**Village of Somers
7511 12th Street
Somers, WI 53171**

**Village Board Meeting
Agenda
Tuesday, May 27, 2025
5:30 p.m.**

AGENDA ITEM: #7 Action on Plan Commission Recommendations (Willow Creek):

TO: Village of Somers Plan Commission
FROM: Luke Godshall, Senior Land Use Planner
APPLN DATE: 03-28-25
RPT DATE: 04-28-25
MTG DATE: 05-12-25
RE: Willow Creek Rezoning & Preliminary Plat

SHEET 1 OF 2

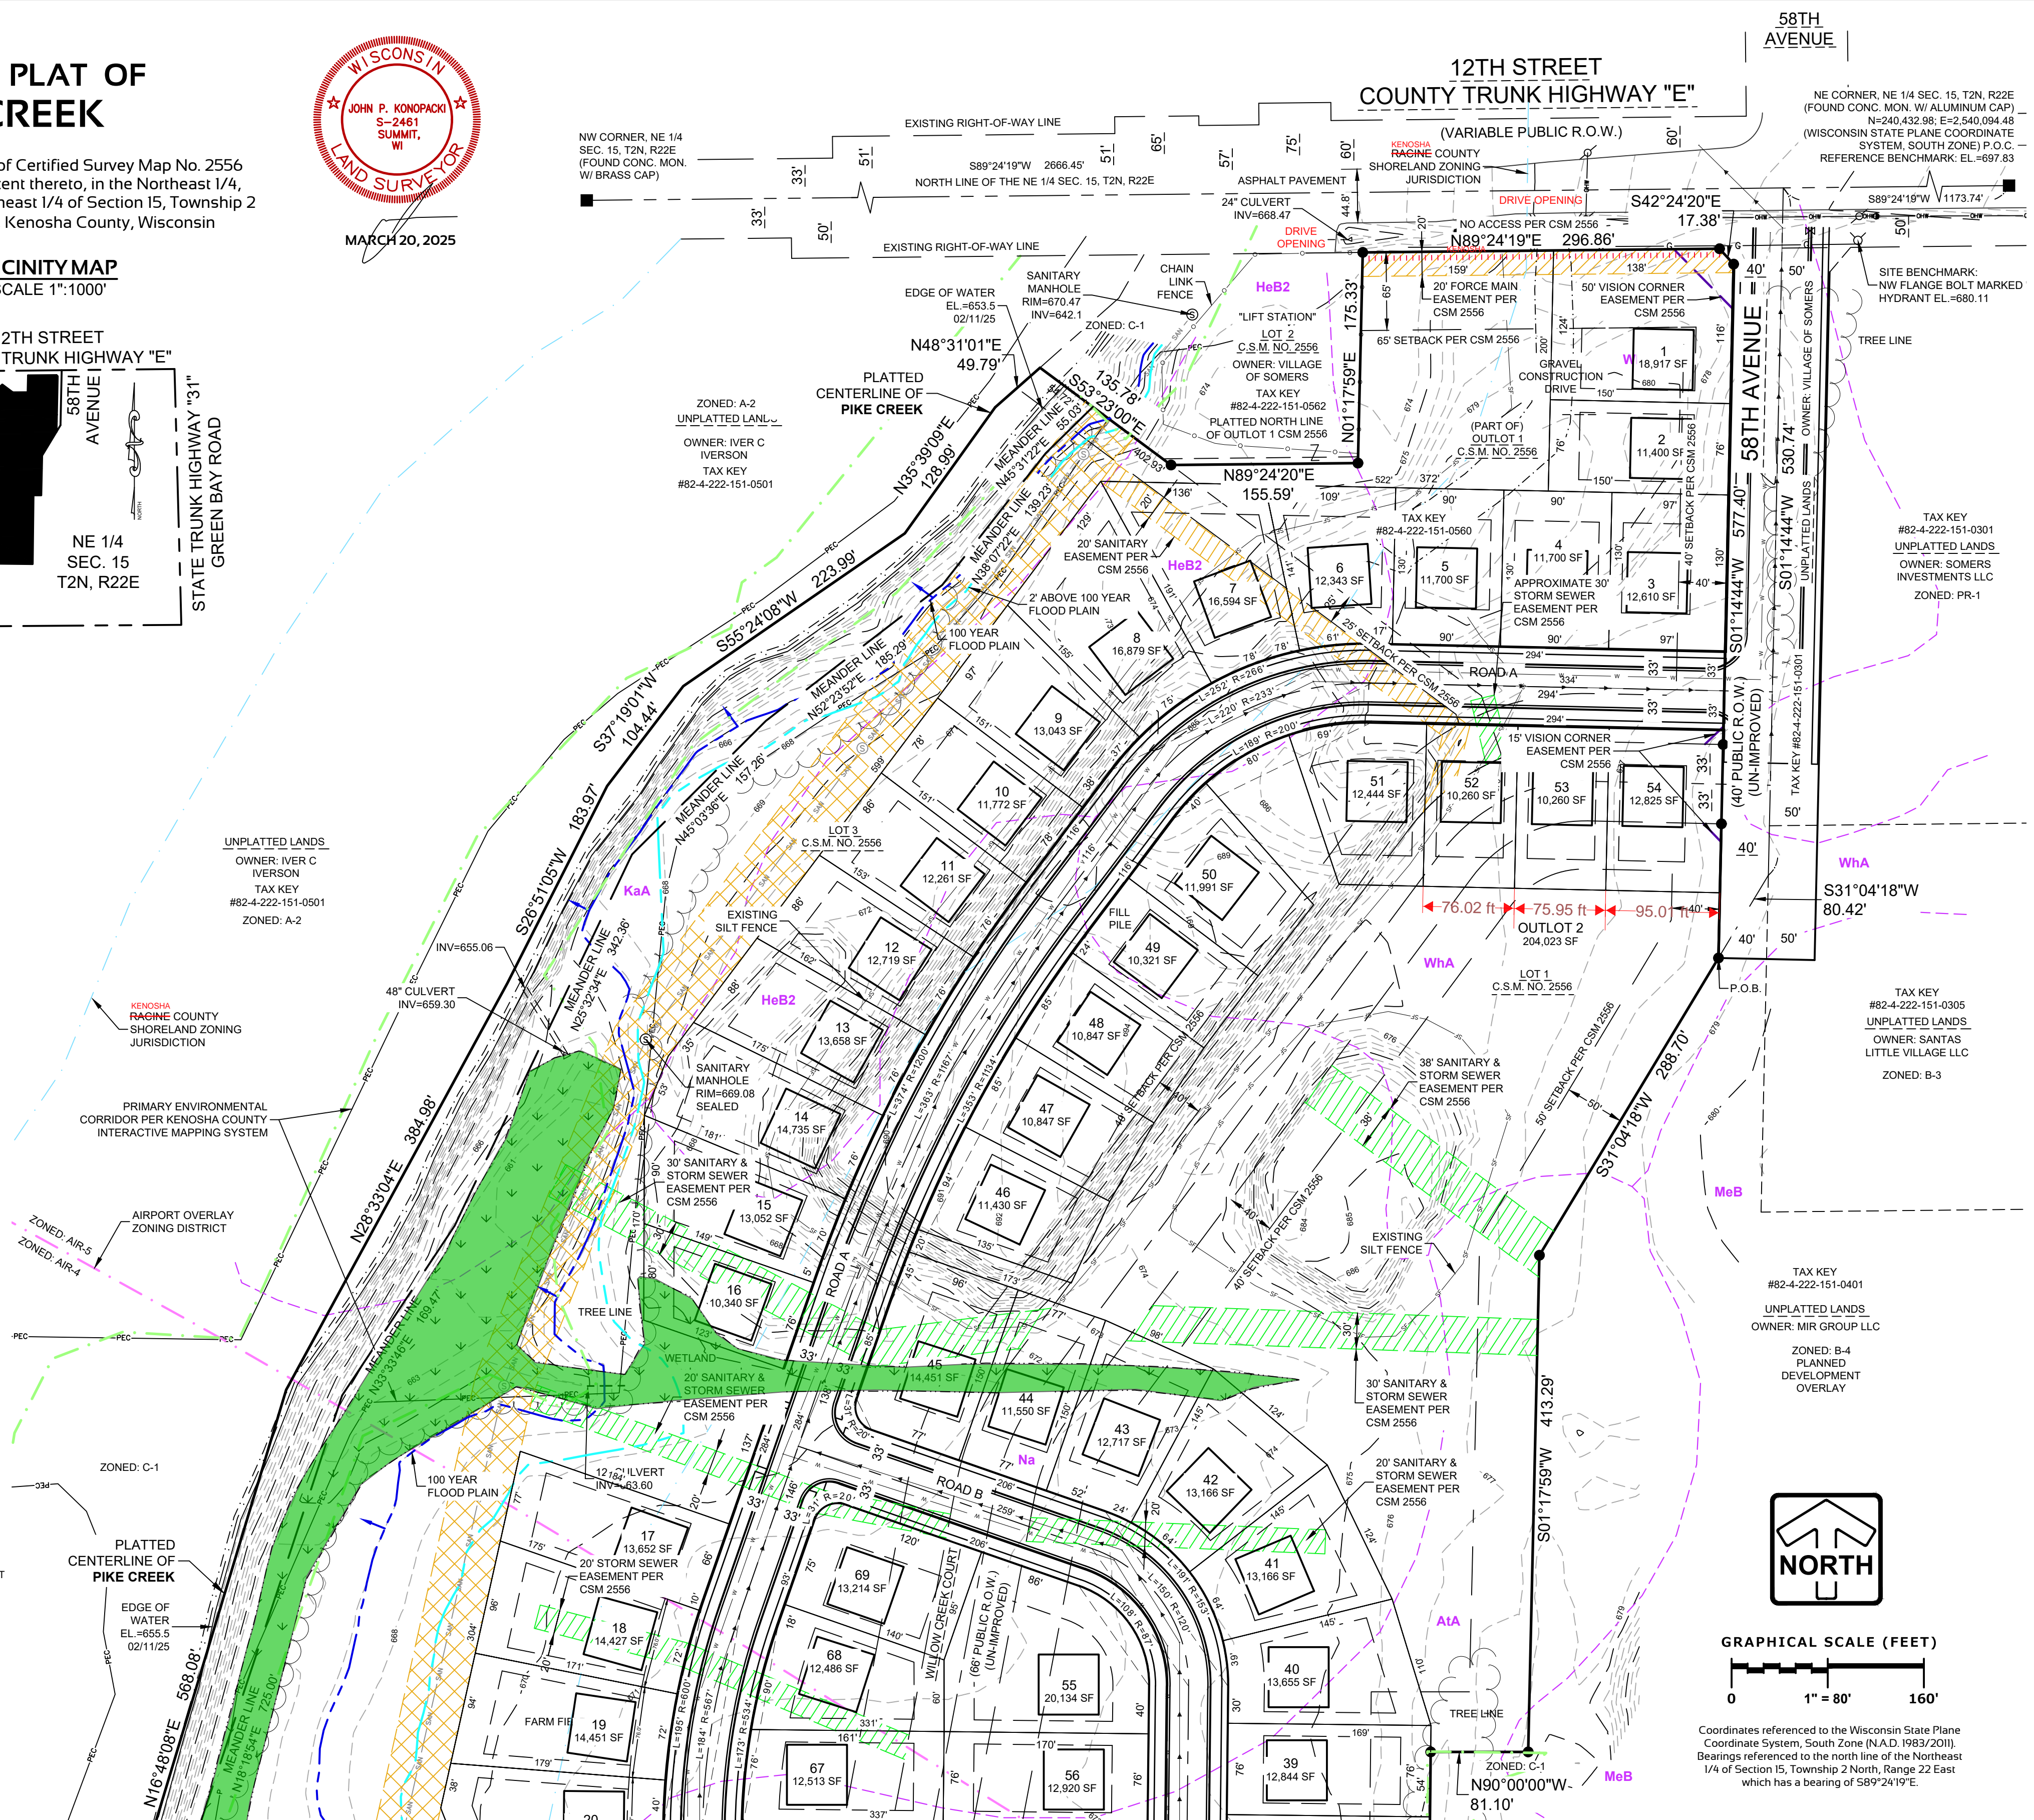
- a. Add Lot dimensions to Lots 25, 26, 27, 40, 41, 42, 43, 49, 50, 51, 52, 53, 54 to confirm conformance with R-5 zoning standards, specifically in regard to required minimum lot width of 75' (or at least 75' of width at the required building setback line if located on a cul-de-sac or curve).

- c. Add a 15'x15' vision corner easement to the southeast corner of Lot 3.
 - d. Add a 15'x15' vision corner easement to the southeast corner of Lot 54.

- e. Per Section 18.27(D)(3) of the Village ordinance, the southeast corner of Lot 3 and the northeast corner of Lot 54 shall be rounded with a minimum radius of 15 feet or of a greater radius when required by the Village Plan Commission.

- f. Per Section 18.27(C)(2) of the Village ordinance, add a temporary cul-de-sac or temporary “T” 25 feet wide extending to each adjacent right-of-way to the southern end of proposed “ROAD B”.

- g. On Sheet 2, duplicate the note from Sheet 1 indicating the adjacent unplatted tax key #82-4-222-151-0501.
 - h. On Sheets 1 and 2, add a note identifying what the green dashed & dotted line represents.

3. The following items shall be revised on the face of the preliminary plat:
 - a. In the legal descriptions on Sheets 1 and 2, revise “Town of Somers” to read “Village of Somers”.

- b. On Sheets 1 and 2, relabel “Road A” as “Willow Creek Court”, and relabel “Road B” as “61st Avenue”.
 - c. On Sheets 1 and 2, revise the Existing Zoning note to read “A-2 General Agricultural District, R-9 Multiple-Family Residential District, C-1 Lowland Resource Conservancy District, Airport Overlay Zoning Districts AIR-4 & AIR-5”.

- d. On Sheets 1 and 2, revise the Proposed Zoning note to read “R-5 Urban Single-Family Residential District & C-1 Lowland Resource Conservancy District”.

- e. On Sheets 1 and 2, revise “Proposed Zoning Requirements” to read “R-5 Urban Single-Family Residential District Requirements”.
 - f. On Sheets 1 and 2 under the Zoning Requirements section, revise “Front” to read “Street Yard” and revise “Front Street” to read “Street Yard”.

- g. On Sheets 1 and 2, revise notations of “Racine County Shoreland Zoning Jurisdiction” to read “Kenosha County Shoreland Zoning Jurisdiction”.
 - h. On Sheets 1 and 2, revise the note for the zoning of adjacent parcel 82-4-222-151-0401 to read “Zoned: B-4 Planned Business District, PUD Planned Unit Development Overlay District & A-2 General Agricultural District”.

- i. On Sheet 1, revise the note for the zoning of adjacent parcel 82-4-222-151-0501 to read “Zoned: A-2 General Agricultural District & C-1 Lowland Resource Conservancy District”.

REVISIONS		SHEET 2 OF 2
NO.	DATE

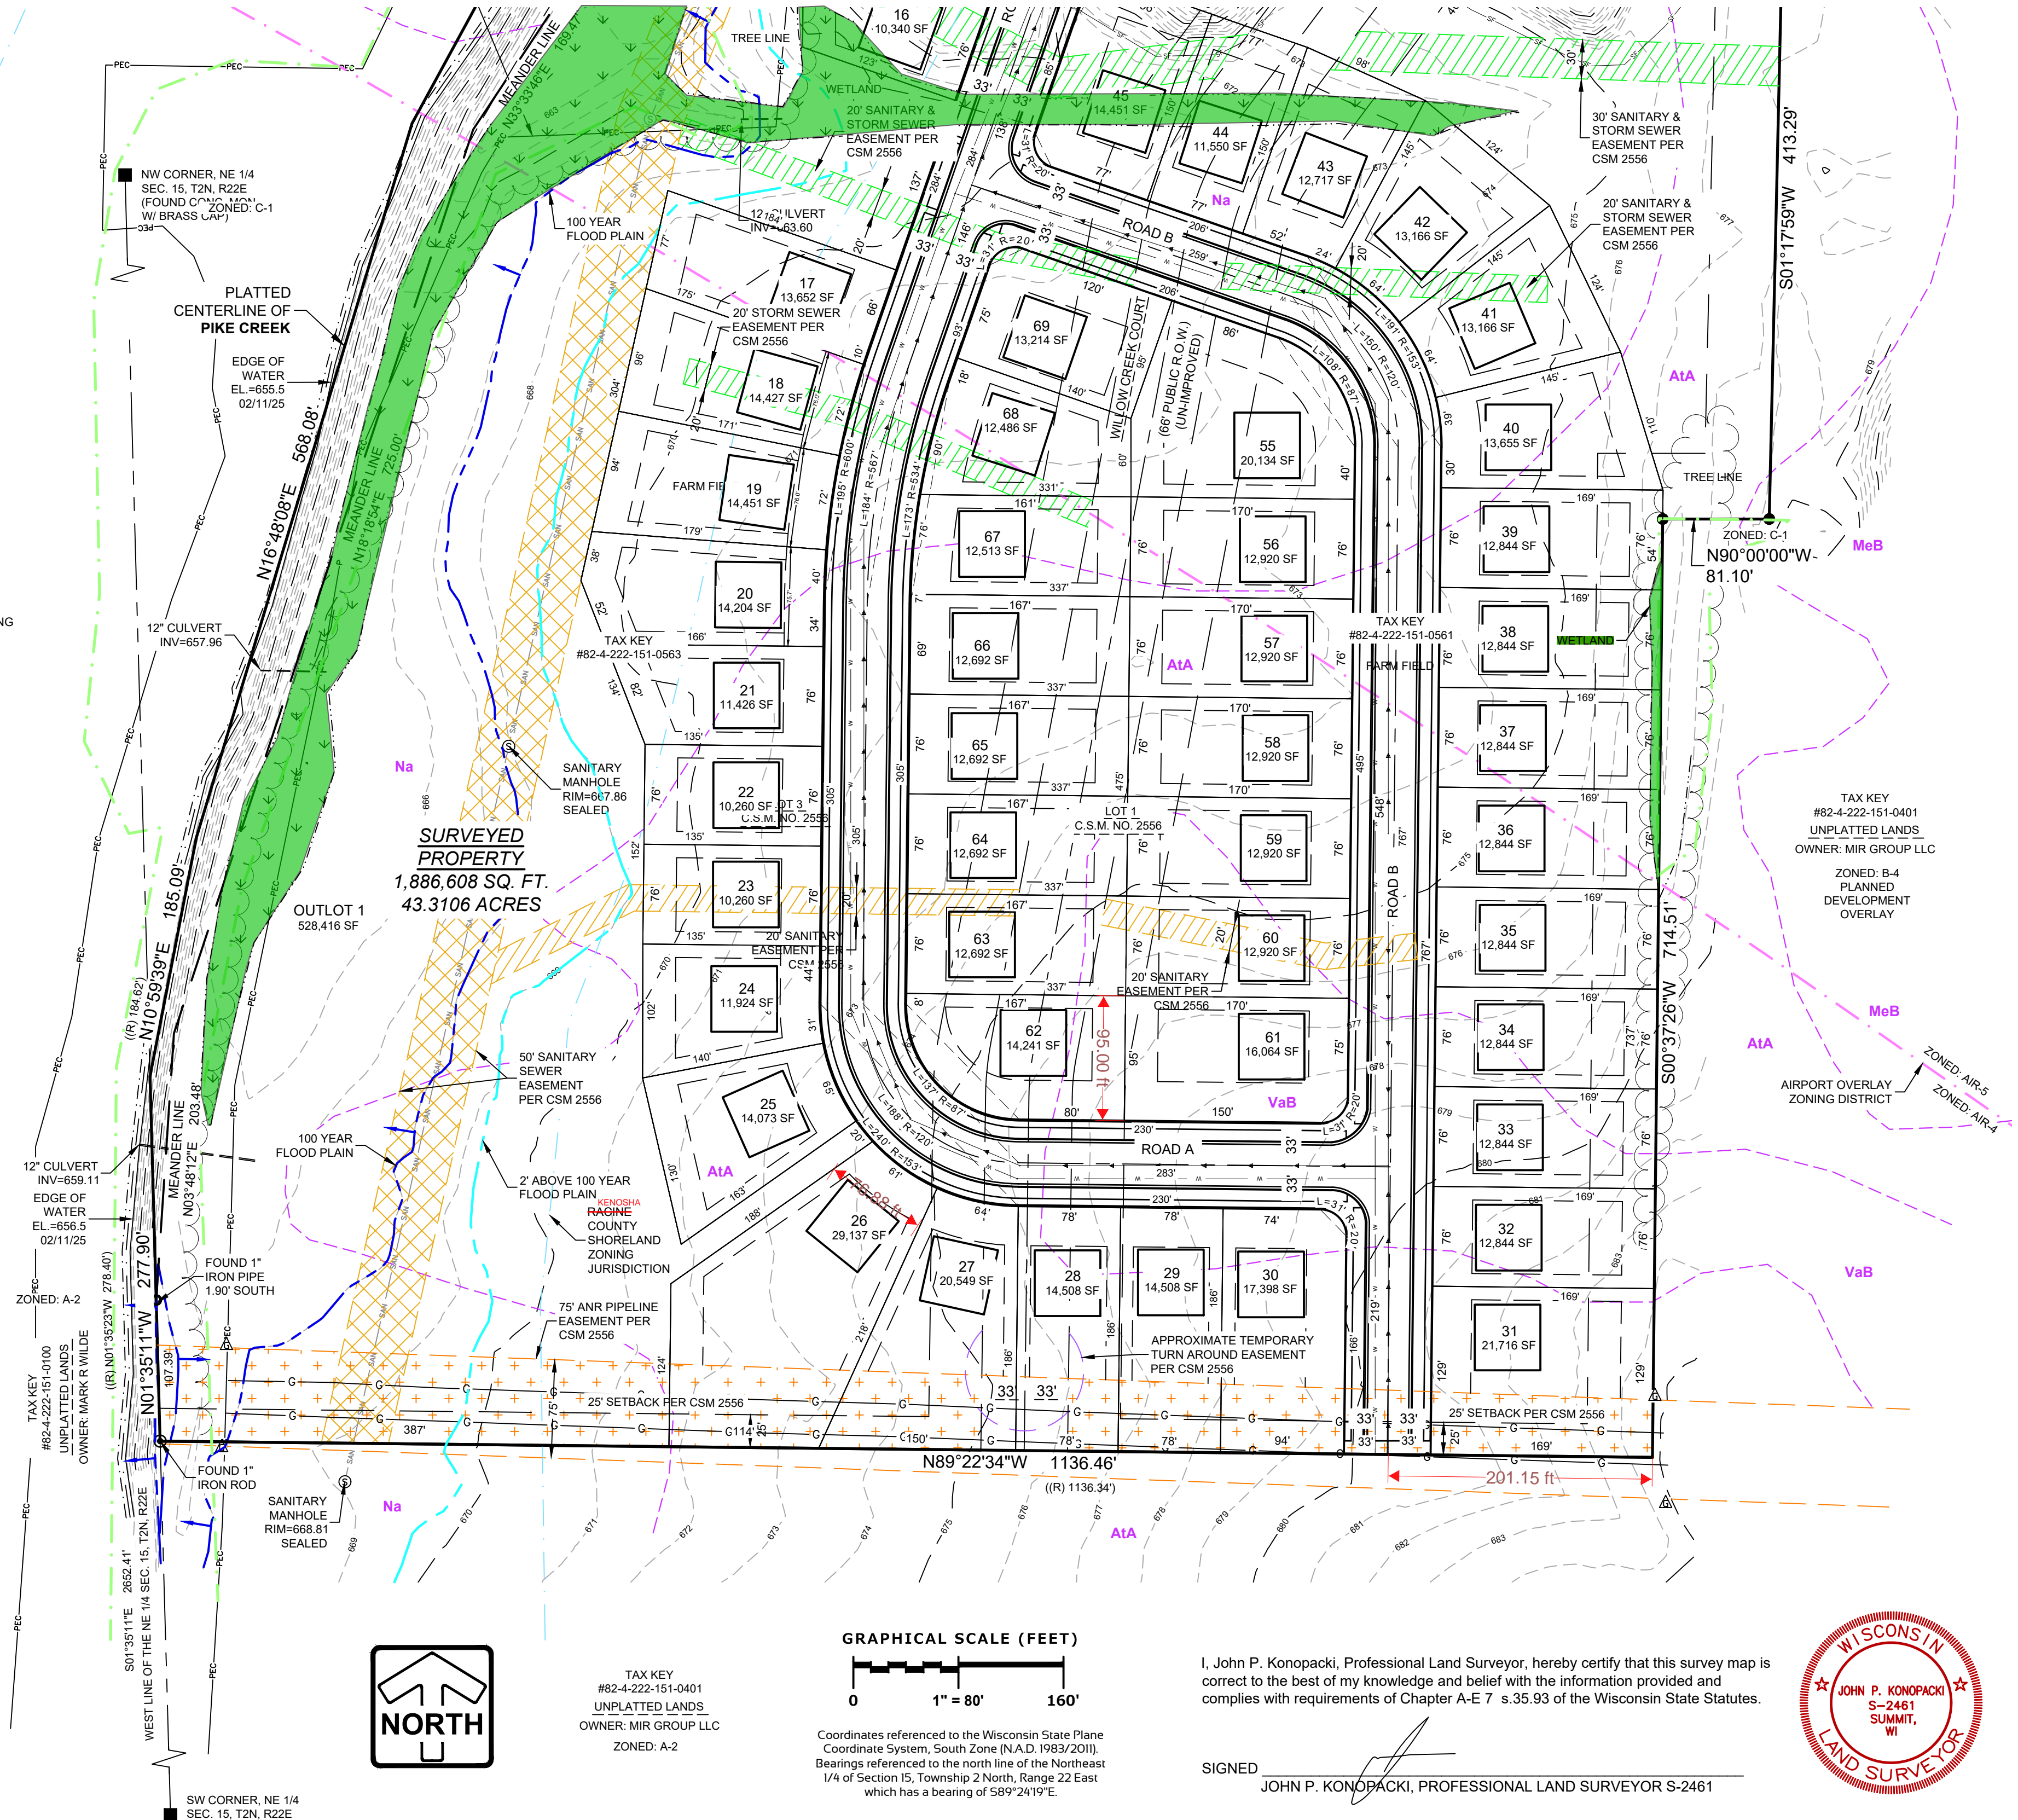
- j. On Sheet 2, relocate the text “ZONED: C-1” so that it does not overlap the text referring to the Sec. 15 monument.
 - k. In Note 13 on Sheet 2, confirm the date of the wetland delineation by Heartland Ecological Group, Inc. (Note 13 indicates wetlands were delineated September 2024, but the submitted Site Plan from Pinnacle Engineering Group dated 3/28/25 indicates the wetlands were delineated March 25, 2025).

- l. On Sheet 2, in the third (3rd) bullet point under the WETLAND PRESERVATION AND PRIMARY ENVIRONMENTAL CORRIDOR RESTRICTION note, replace “Kenosha County” with “the Village of Somers”.

- m. On Sheet 2, revise the surveyor’s certification to include language certifying that the preliminary plat is a correct representation of all existing land divisions and features and that the plat complies with the provisions of Chapter 18, the Village of Somers Land Division and Platting Control ordinance.
